Centrifugals - In-Line

3 PHASE
BEGINNING WITH
SERIAL NO. 950789

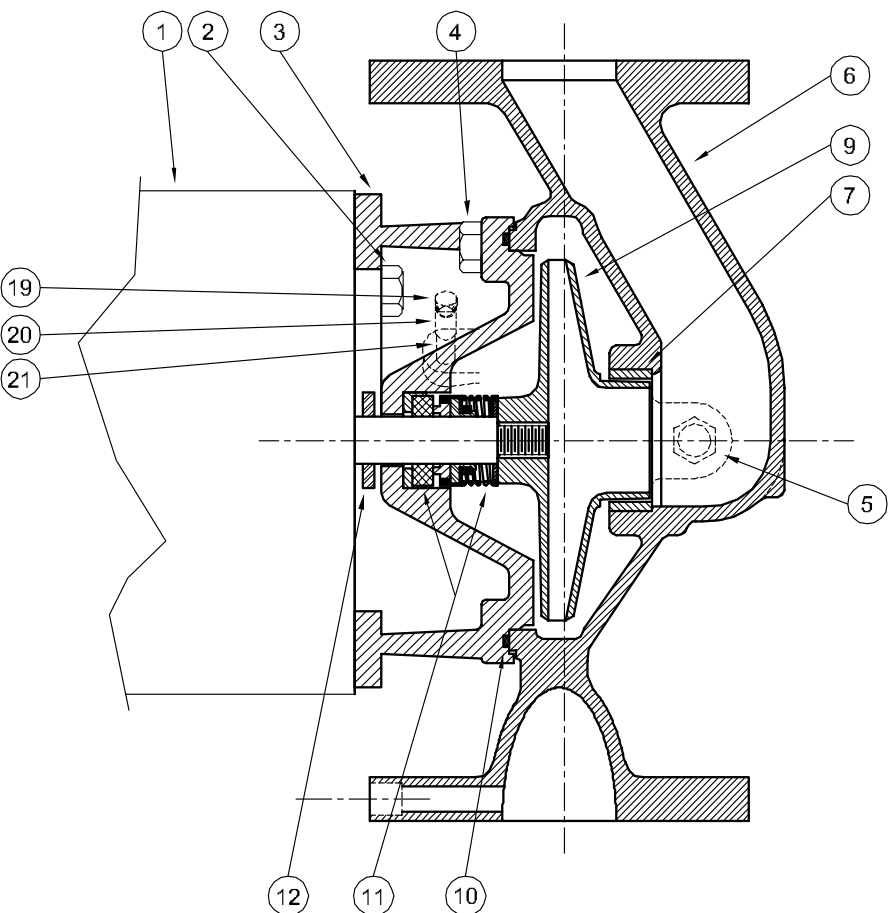
NOTE: Beginning with Serial No. 950789, all pumps with three-phase motors are equipped with an impeller lock screw and washer as illustrated. All other methods of securing the impeller to the shaft have been discontinued.

If it is necessary to disconnect three phase motor leads while new replacement impeller is installed on any pump prior to serial No. 950789, leads should be tagged to insure correct motor rotation and prevent impeller spin-off.
